Planning Research Corporation

October 30, 1986

On August 25, 1986, PRC Engineering, contractors for the EPA Region VI, conducted a "lost interim status inspection" at the Louisiana Division of Dow Chemical. Below is a list of additional information which was requested. This information is included in the referenced attachments:

RESPONSE TO JUNE 25, 1985 RCRA GROUNDWATER INSPECTION REPORT
RECEIVED SEPTEMBER 12, 1985
DOW CHEMICAL U.S.A., LOUISIANA DIVISION

Location of Monitor Wells at the Northwest Landfill Area.

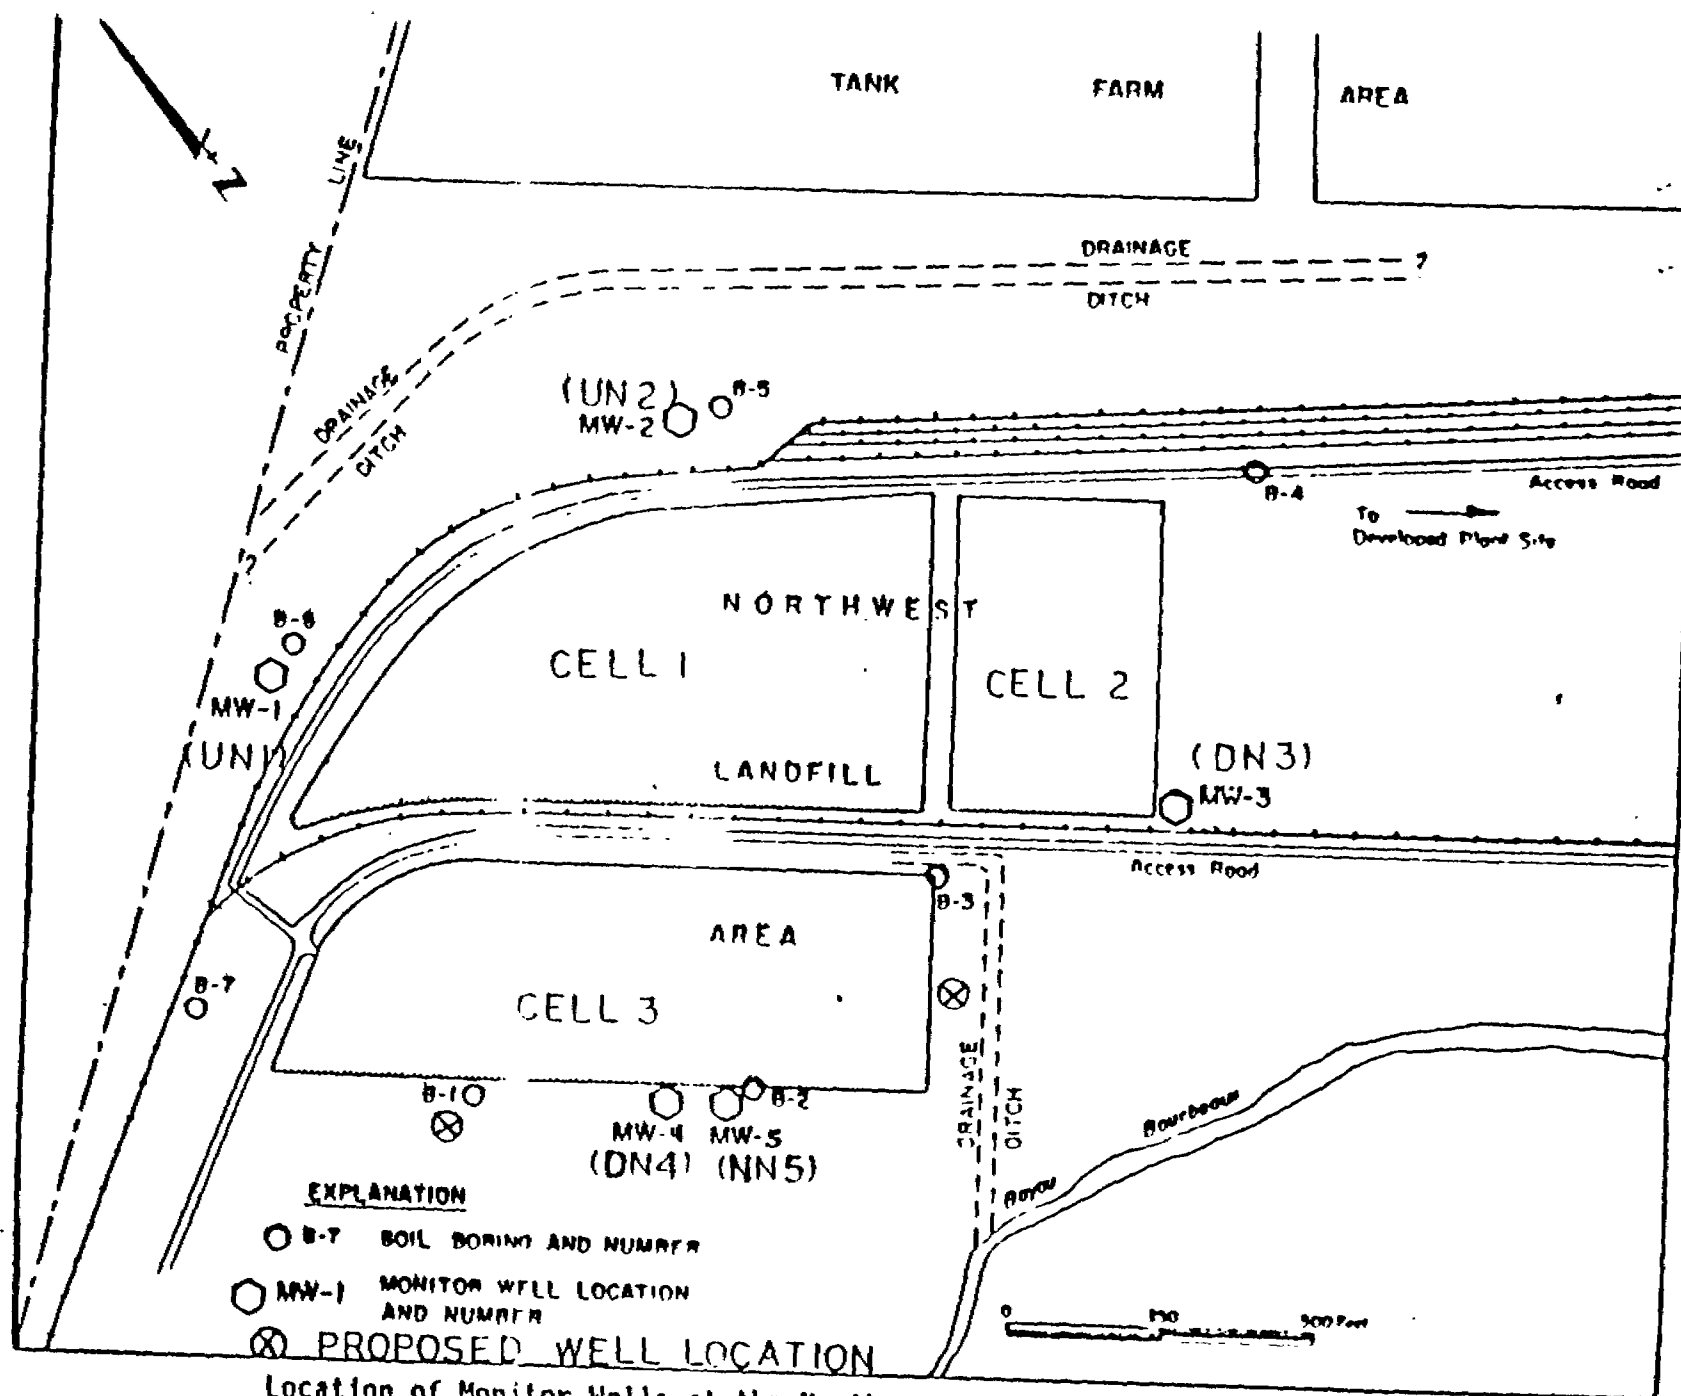
Dow's Comment

The monitoring well network at the CPE surface impoundment consists of four wells NC1, NC2, NC3, and NC4. The groundwater flow direction as determined by the current groundwater monitoring network at the CPE surface impoundment appears to shift slightly throughout the year. A total reversal of flow has not been observed, but rather a shift from a predominantly westerly direction to a periodic flow in a southwesterly direction. The groundwater flow direction is in a westerly direction (Dow coordinates) approximately ten months out of the year. During this time, wells NC1 and NC2 function as downgradient wells. Periodically, the groundwater flow direction has been observed to shift slightly to the southwest. During this time, wells NC1 and NC2 function as downgradient wells. NC3 is located such that in the event the groundwater flow direction shifts slightly to the north then NC3 will function as a downgradient well.
